Thom Roy—Fremont Building Inspector

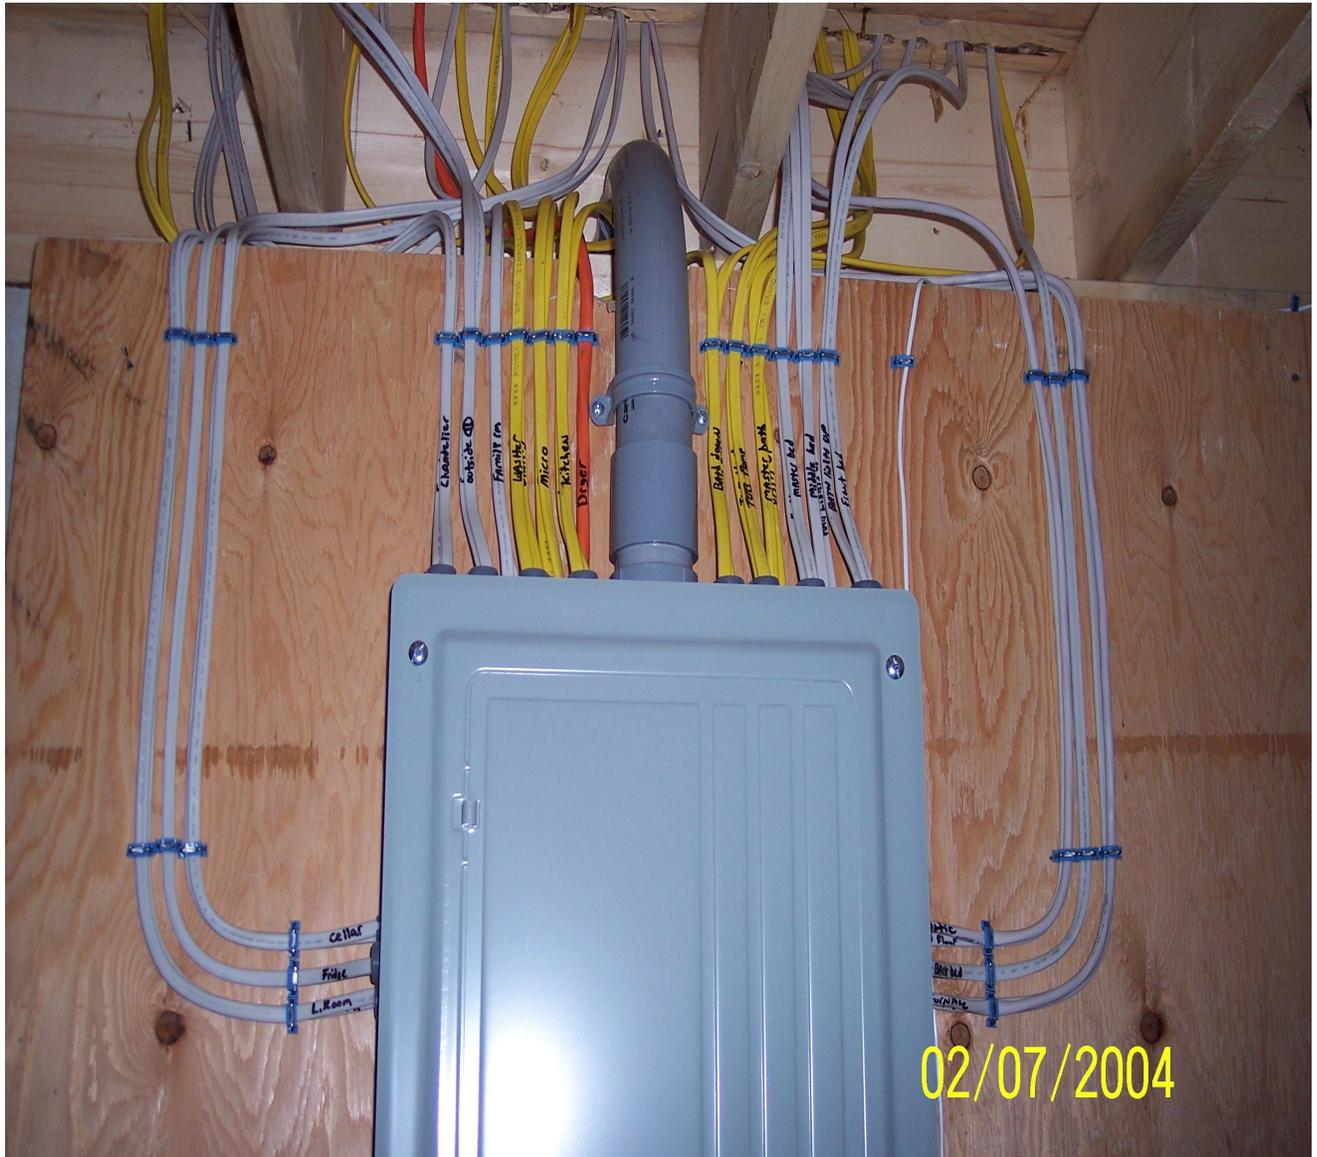
**Service wrench provided
Tighten when leaking?**

**When CSST is used
Manufacturer's nail plate is required**

**Proper nail plates required at
penetration of framing members
for top and bottom plates**

**Gas manifold for distribution
with shut-offs for each branch line**
